**BOARD OF COUNTY COMMISSIONERS  
ESCAMBIA COUNTY, FLORIDA**

**ADDENDUM NUMBER 2:**

Re: **Blower / Flare Station, Perdido Landfill  
Specification Number: PD 09-10.028**

**This Addendum #2 provides for the following questions and answers and a Process Flow Diagram:**

Proposed Process Flow Diagram and Minimum Requirements for Instrumentation and Control  
 (actual details may vary based on manufacturer specifics while meeting the overall performance requirements of the specifications)

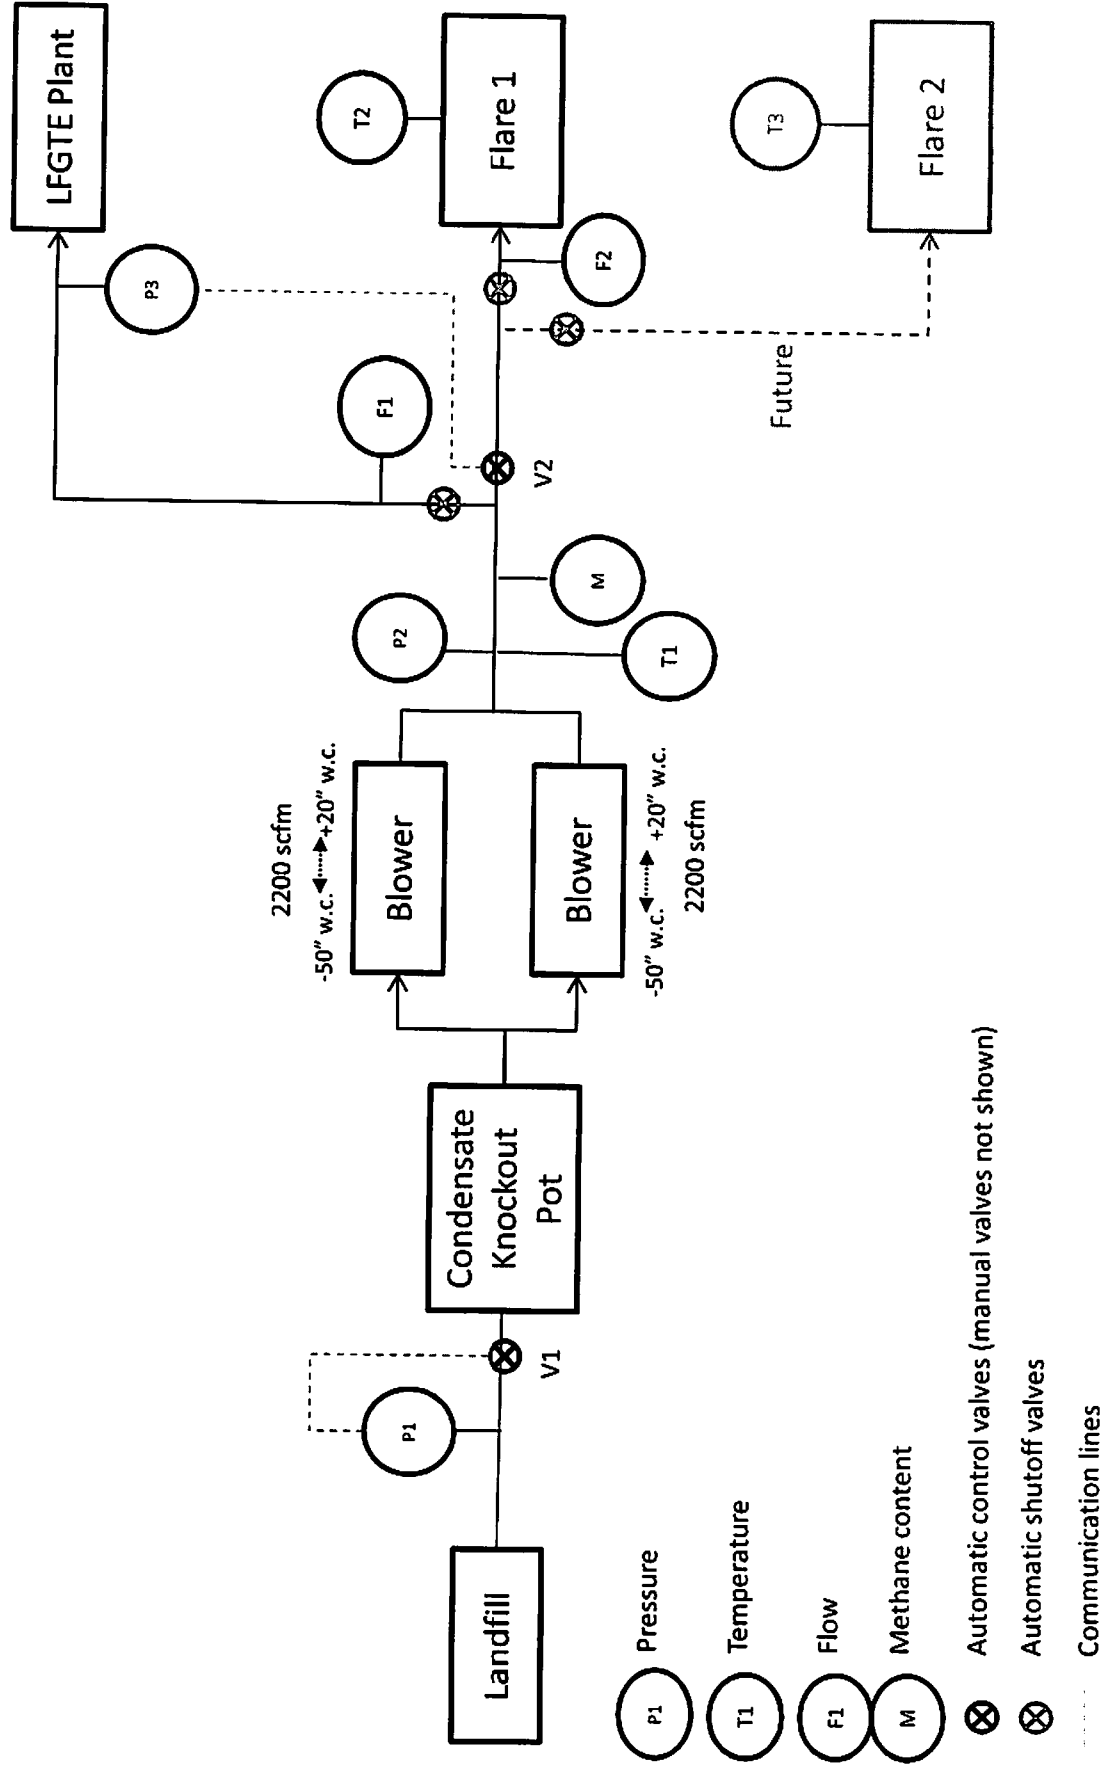
- Q. Spec 11910, section 2.09.B, it states, "... blower turns on (if not already operating to supply gas to the generating plant)..." Is the blower to be capable of operating without the flare? Please describe this operation and what instrumentation and safeties are to function with the blower operating in this mode.

- Q. Spec 11910 section 2.09.G, it states a shutdown will include "the automatic shutoff valve is closed, the blower(s) is shut down (if generation plant is not operating),..." How will the flare/blower system know if the gas plant is operating?

- A. Blower will need to operate even if the flare is not operating. Blower will be the source to supply gas to the generating plant. If the flare and both the engines at the generation plant are down, the blower will need to stop operating. The process diagram (included in this addendum) and the technical specifications explain the automatic control system that is required for routing the gas to the flare and the generating plant. The bidder shall provide a blower-flare package with control systems to meet the performance requirements while operating safely.

- A. Based on the pressure sensor provided at location P3 on the gas pipeline from the blowers to the generation plant.
- Q. Spec 11910, section 2.10.C: What if the demand of gas from the gas plant results in a higher vacuum than the operator entered setpoint? How should the control system react or operate?

- A. Installation will be part of the GCCS expansion project and not part of this project. **A process flow diagram is included with this addendum.**
